SERVICE BULLETIN

PURPOSE : INFORMATION	ISSUE NO. : MSB-07E54-004	DATE : 2007-07-05
SUBJECT : PASSWORD ERASING PROCEDURE FOR HANDS-FREE-ECU	<div> <div><MODEL></div> <div>(EUR)</div> <div>OUTLANDER</div> <div>(GS45X)(CW0W)</div> </div> <div> <div><M/Y></div> <div>07</div> </div>	
GROUP : CHASSIS ELECTRICAL

According to the design change, the password erasing procedure for the hands-free-ECU has been established in the applicable Workshop Manual. This Service Bulletin contains the new procedure.

Attachment 1

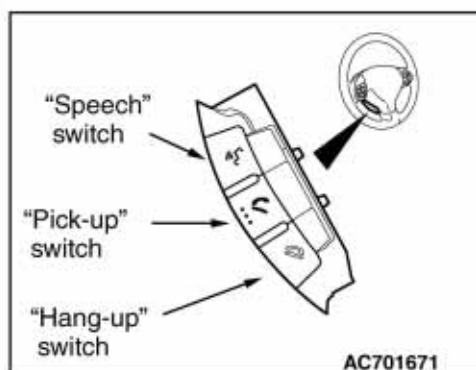
<Added>

ERASE THE PASSWORD

The 4-digit password set by security function can be erased by operating the hang-up switch.

1. Turn the ignition switch to the "ON" or "ACC" position, and check if the audio unit or the audio visual navigation unit is activated.
2. Check that the hands free cellular phone system is not in voice recognition mode.
3. Press and hold the hang-up switch for approximately 2 seconds (1.5 seconds or more).
4. Within approximately 10 seconds after performing step 3, press and hold the hang-up switch for approximately 2 seconds (1.5 seconds or more) twice again.

NOTE: Even if the password is erased, guidance such as voice guide is not provided.

5. After the operation, check if the lock with the password is unlocked. If the lock is not unlocked, repeat from step 2.
